RE: 204-210 Parramatta Road, Auburn, NSW 2144 – Facts and Contentions

In response to the Statement of Facts and Contentions (case no: 2022/00175835) raised by Cumberland City Council, Meinhardt Group has been engaged by Skematics to address all stormwater contentions identified in Part B – Contentions. The stormwater contentions raised by Council have been outlined below with responses provide by Meinhardt Group.

STATUS FOR INFORMATION ONLY NOT FOR CONSTRUCTION	DESIGNED	DRAWN	APPROVED	DATE	SCALE @A1	SHEET
	JD	SY	LM	28.11.19	1:100	OF
	PROJECT No 121465		DRAWING No C101		REV P04

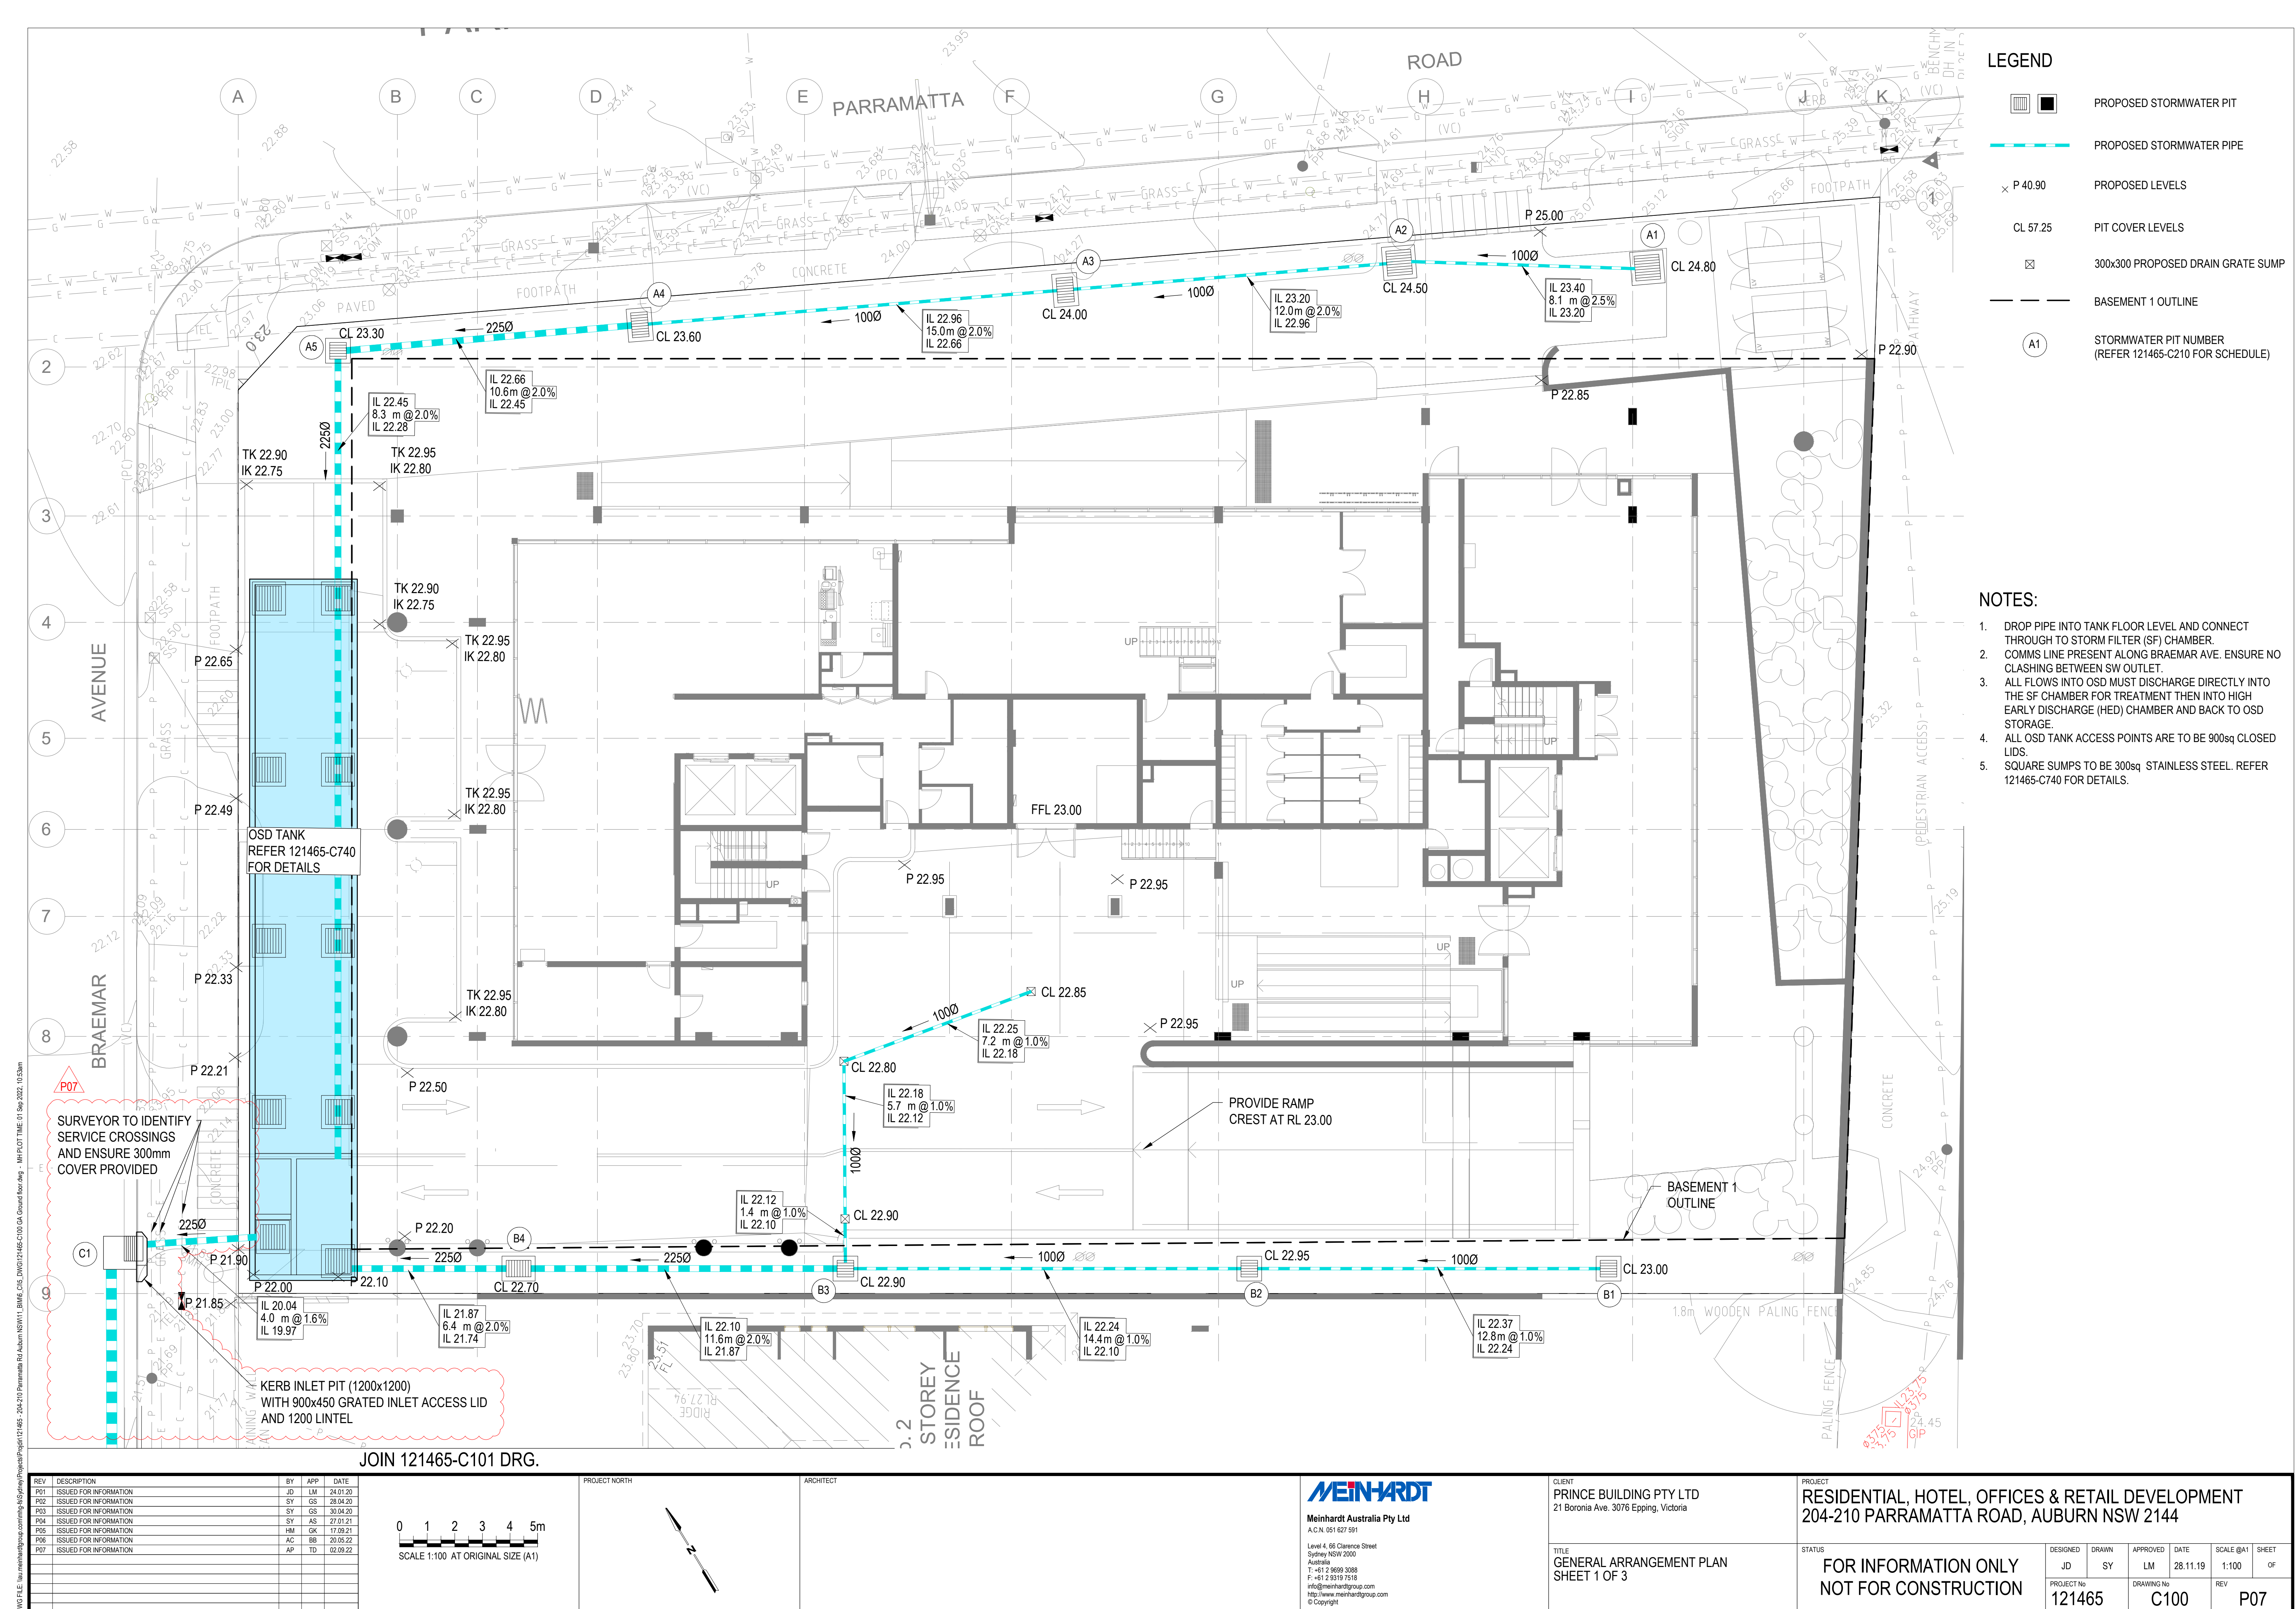
- (a) The development has not made provision for the stormwater pipeline extension underneath the kerb and gutter. The proposed stormwater drainage works on the public road reserve at Braemar Avenue would interfere with all existing services and neighbours’ driveways.

- (b) Fully detailed designs, including a long section of the pipe, a pipe trench cross-section detail and connection point into Council's drainage system, have not been submitted for all proposed drainage works within the road reserve. All the design details should be provided, including hydraulic grade lines based on the 5% and 1% AEP storms.

The stormwater drainage network proposed on Braemar Avenue (refer to drawing sheet C100, C101, & C102) has been located underneath the kerb and gutter. The proposed stormwater drainage network will not impact existing services located in Braemar Avenue verge or existing property driveways. Additional kerb inlet pits have been proposed to collect surface runoff in Braemar Avenue. The proposed stormwater drainage network will improve the existing stormwater drainage infrastructure in Braemar Avenue.

Refer to drawing sheet C210 for stormwater drainage long section, pipe trench cross-section detail. Refer to drawing sheet C102 for connection point into Council's drainage system. Refer to longitudinal section of the proposed stormwater drainage network for the hydraulic grade lines based on 5% and 1% AEP storms.

The pedestrian footpath and grated inlet pits have been identified on survey plans and shown on drawing sheet C100 and C101. The survey additionally identified an existing dish drain on the pedestrian crossing as shown on drawing sheet C101.

PROJECT RESIDENTIAL, HOTEL, OFFICES & RETAIL DEVELOPMENT 204-210 PARRAMATTA ROAD, AUBURN NSW 2144	STATUS FOR INFORMATION ONLY NOT FOR CONSTRUCTION	DESIGNED TD	DRAWN TD	APPROVED LM	DATE 22.01.20	SCALE @A1 AS SHOWN	SHEET OF
PROJECT No 121465	DRAWING No C740	REV P04

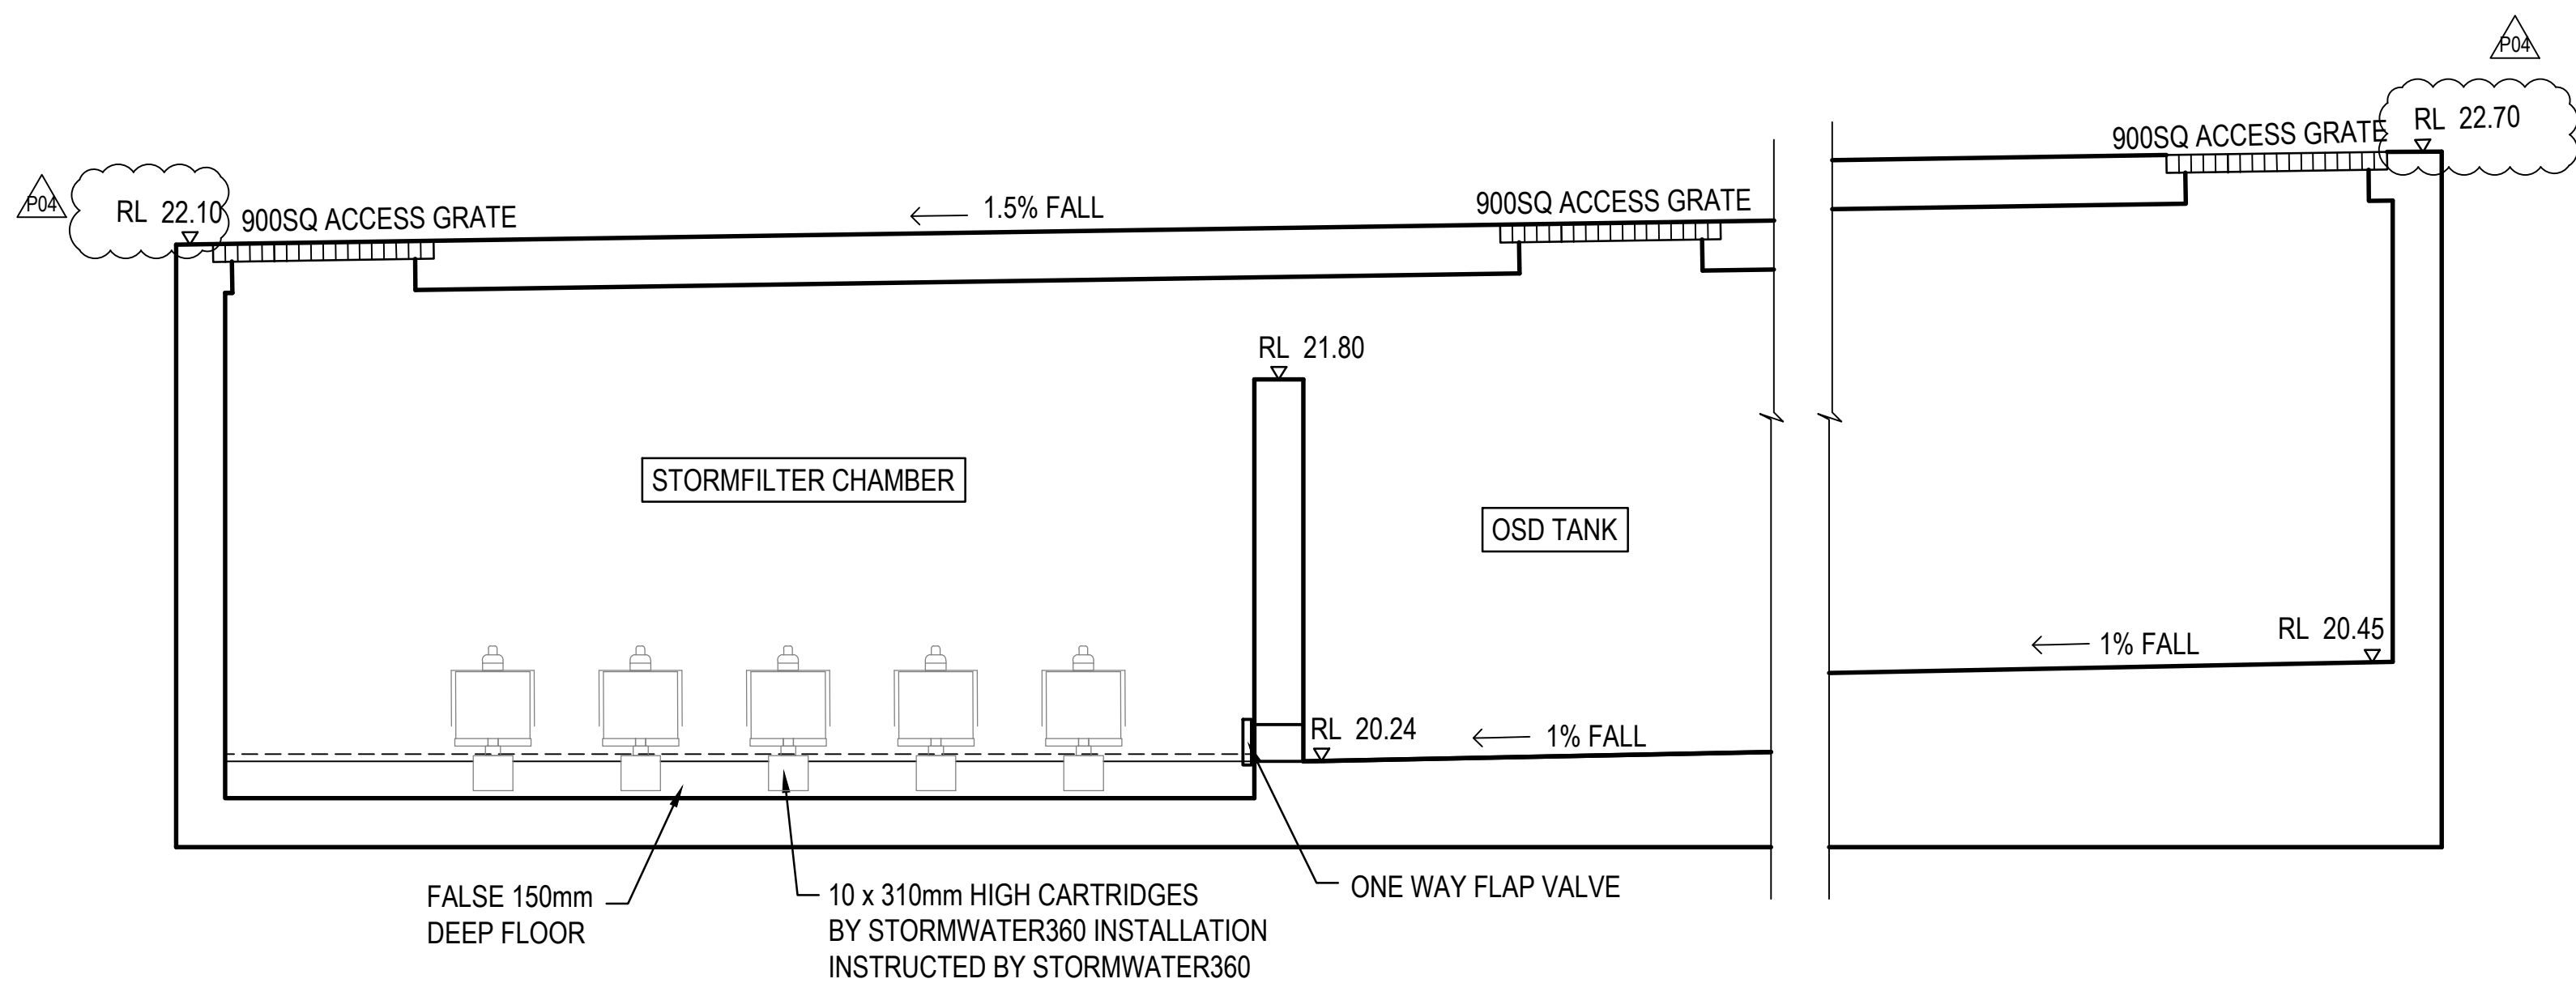
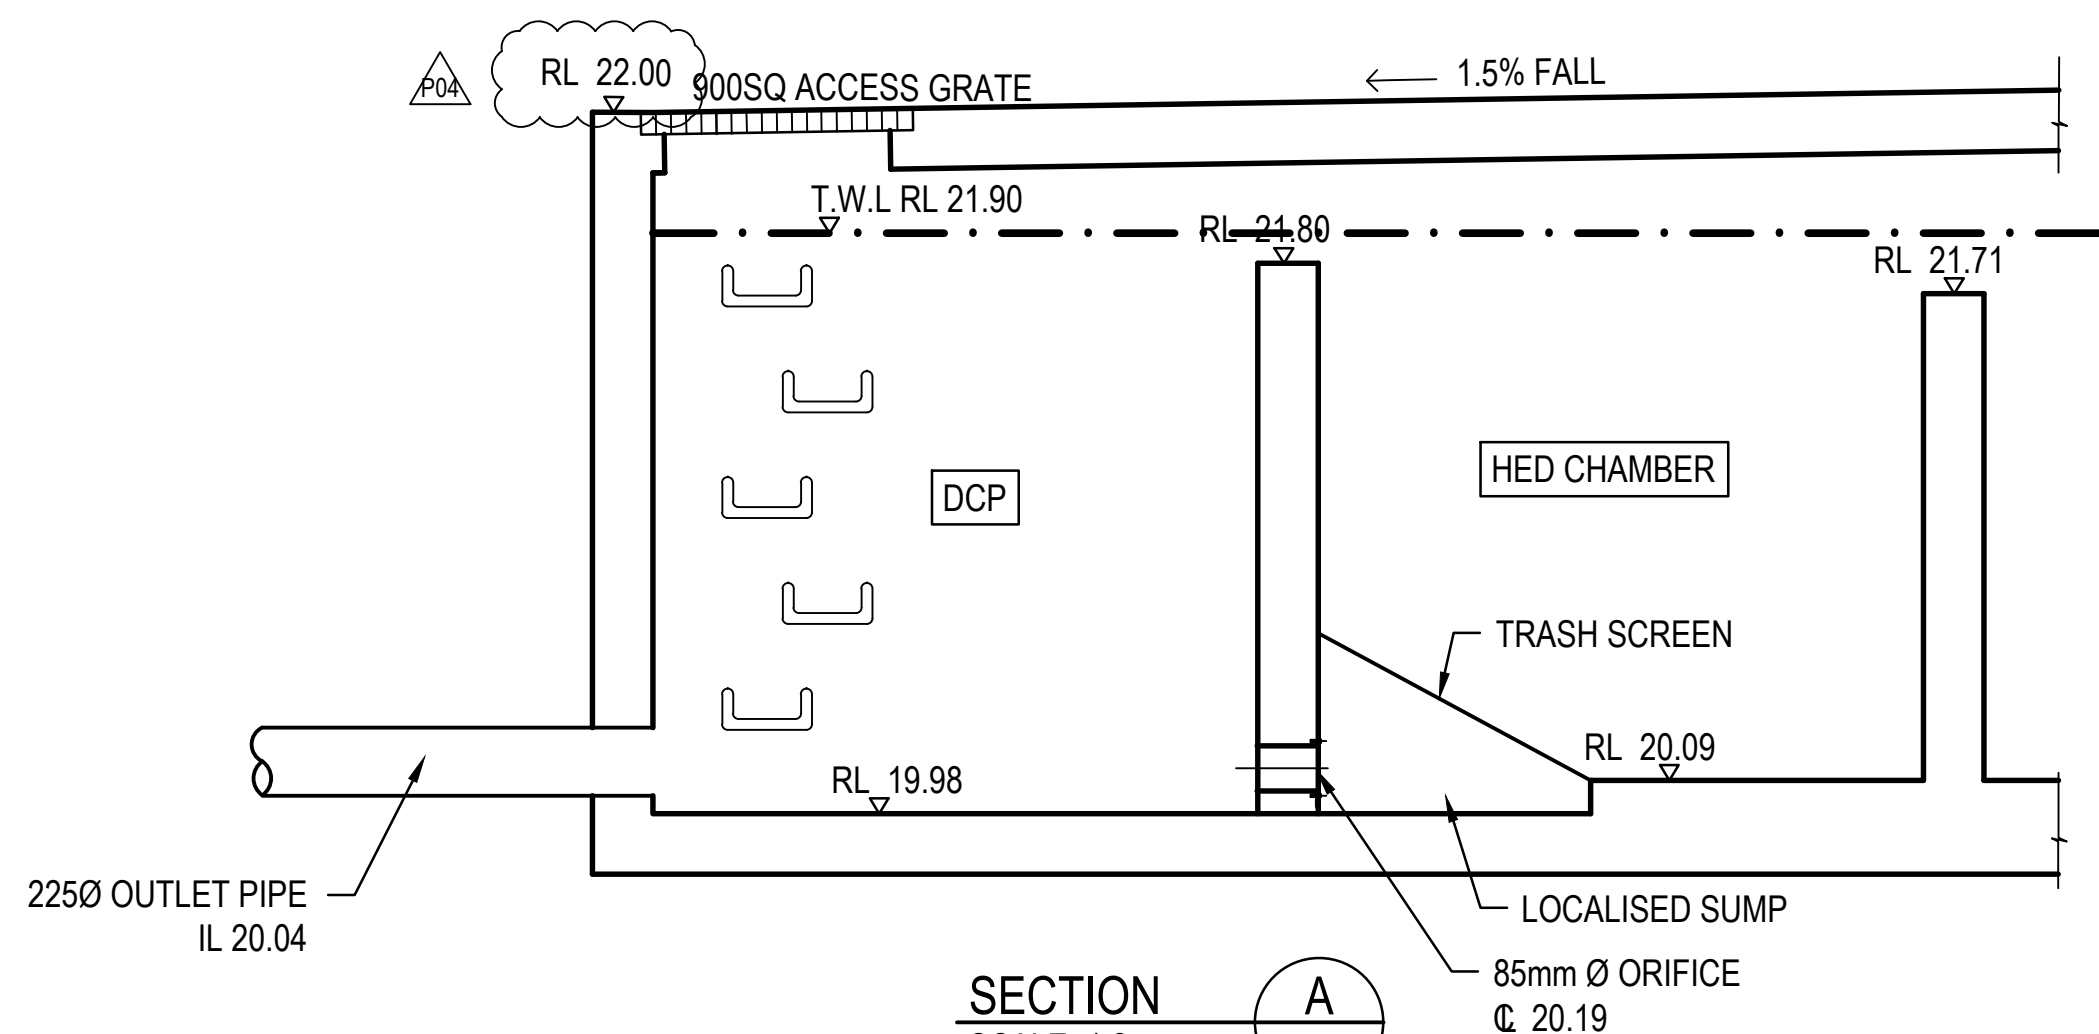
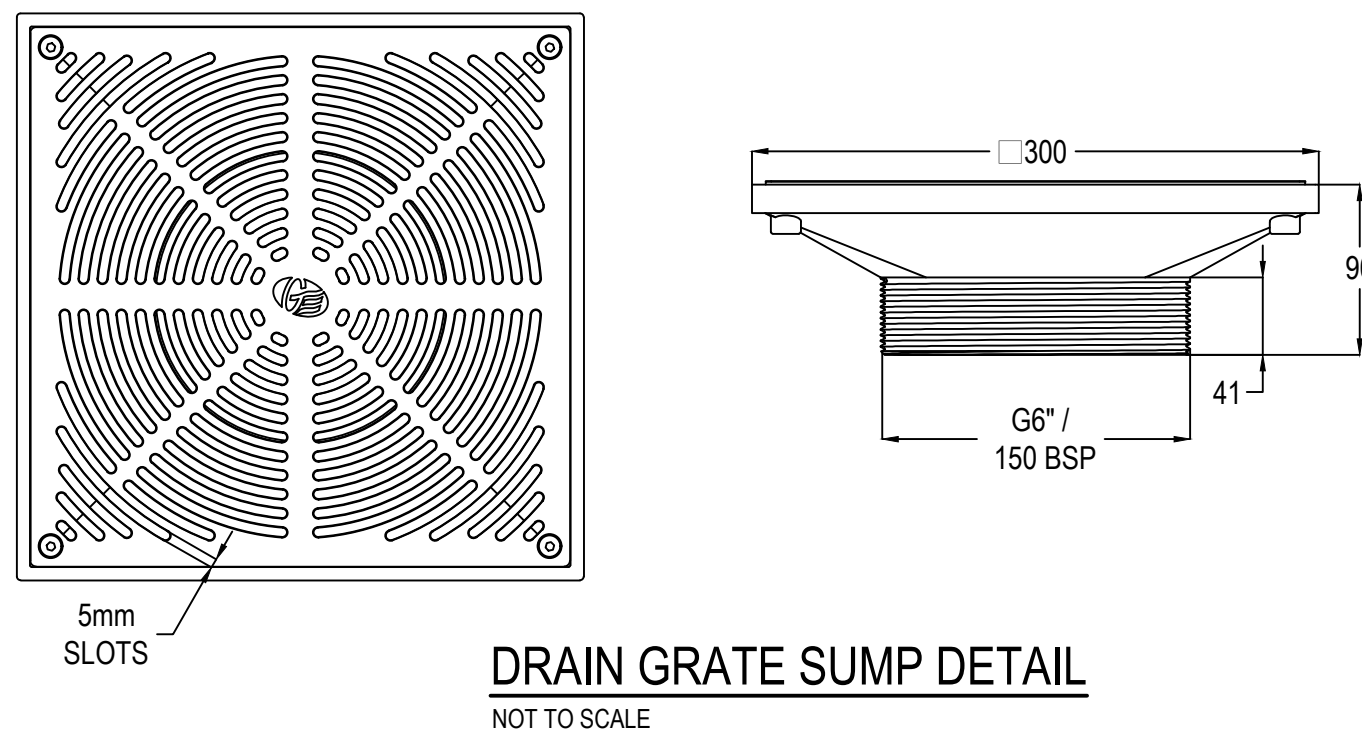
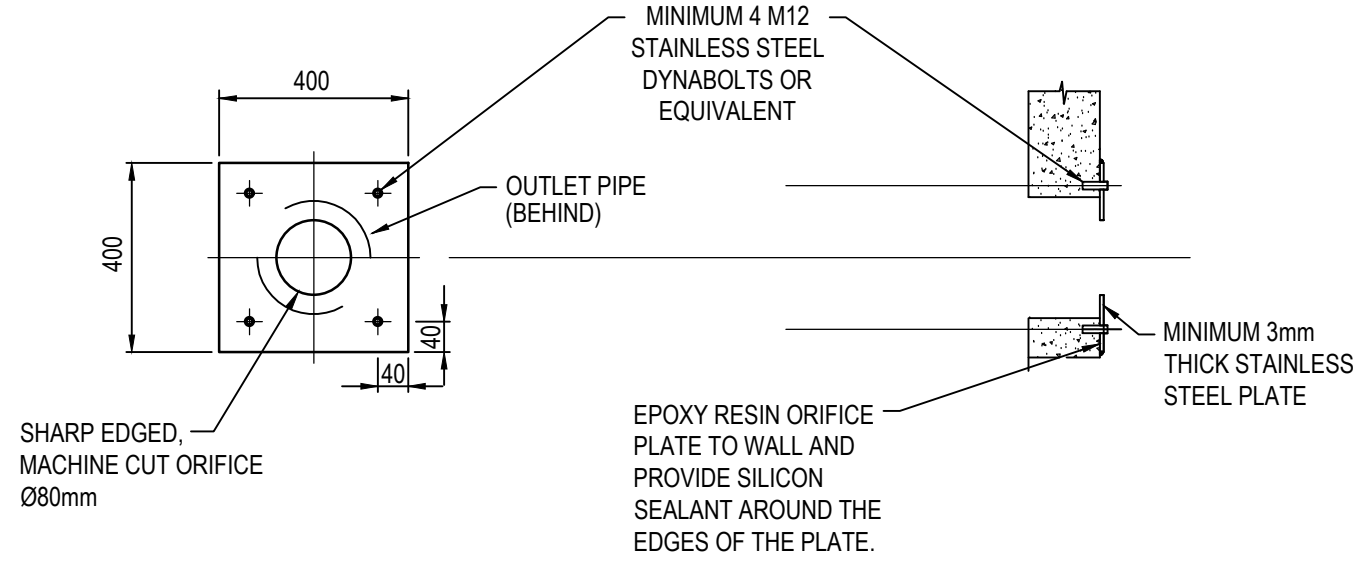
- (c) The development has not designed the on-site detention system as a submerged outlet. The orifice outlet should be designed to function as a submerged outlet, with submerged conditions to be reflected in the on site detention (OSD) calculations. OSD should be provided in accordance with the Stormwater Drainage Part G4 of the Cumberland Development Control Plan 2021 and the Upper Parramatta River Catchment Trust "On-Site Detention Handbook" (Third edition).

The proposed development has provided on-site drainage and an on-site detention system in accordance with Cumberland Development Control Plan 2021 and the Upper Parramatta River Catchment Trust “On-site Detention Handbook” (Third edition). Refer to drawing sheet C100, C210, C740 & C800.
